Project	IEEE 802.16 Broadband Wireless Access Working Group < <a href="http://ieee802.org/16">http://ieee802.org/16</a> >	
Title	OFDMA-based Ranging within Relay Zone	
Date Submitted	2007-03-15	
Source(s)	Kanchei (Ken) Loa, Yi-Hsueh Tsai, Yung-Ting Lee, Shiann-Tsong Sheu, Frank C.D. Tsai, Youn-Tai Lee, Hua-Chiang Yin, Heng-Iang Hsu, Chih-Chiang Hsieh Institute for Information Industry 8F., No. 218, Sec. 2, Dunhua S. Rd., Taipei City, Taiwan.	Voice: +886-2-2739-9616 Fax: +886-2-2378-2328 <a href="mailto:loa@nmi.iii.org.tw">loa@nmi.iii.org.tw</a>
Re:	IEEE 802.16j-07/007r2: "Call for Technical Comments and Contributions regarding IEEE Project 802.16j"	
Abstract	This document is to define operation of OFDMA-based ranging within relay zone in IEEE 802.16j-06/026r2.	
Purpose	Adopt the text proposal in this document	
Notice	This document has been prepared to assist IEEE 802.16. It is offered as a basis for discussion and is not binding on the contributing individual(s) or organization(s). The material in this document is subject to change in form and content after further study. The contributor(s) reserve(s) the right to add, amend or withdraw material contained herein.

## OFDMA-based Ra

Figure 1 Proposed Ranging Code Sets within Relay Zone

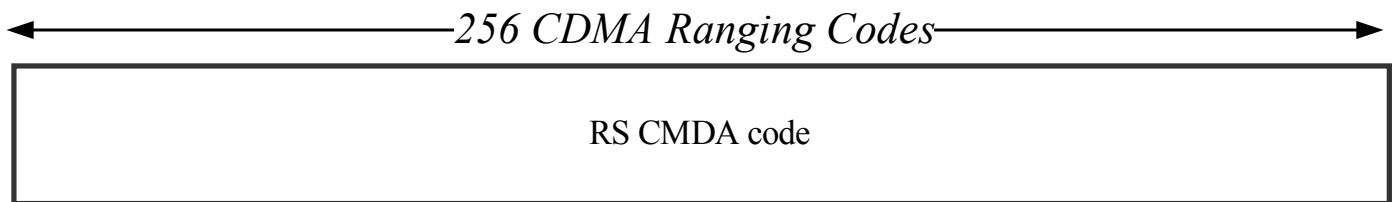
A new ranging code sets, “RS CDMA code within relay zone”, are proposed for relay station operation. The allocation of the two ranging code sets is determined by MR-BS.
